Revision (4) March 2021

Dealer Service Instructions for:

Emissions Recall T21 Reprogram Engine Control Unit

2004 - 2006 (VA) Dodge Sprinter

Figure 3 – Install Adapter Wiring Harness

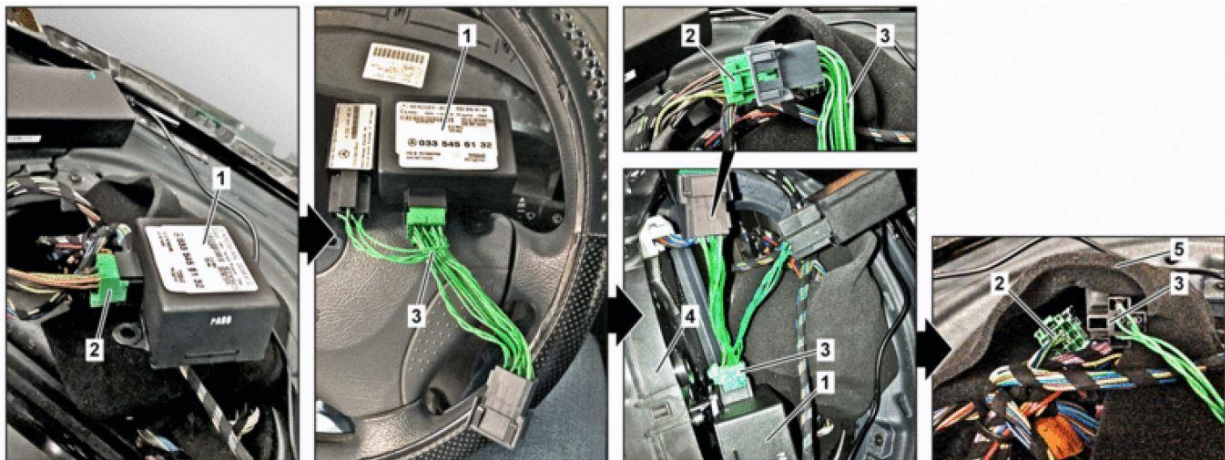
- 24. Install adapter wiring harness (3) and connect to RKE immobilizer module (1) (Figure 3).
- 25. Connect electrical connector (2) to adapter wiring harness (3) (Figure 3).
- 26. Wrap electrical connector (2) together with adapter wiring harness (3) in foam material (5) already present in the instrument panel (Figure 3).

NOTE: The foam material (5) will serve as chafe protection and soundproofing (Figure 3).
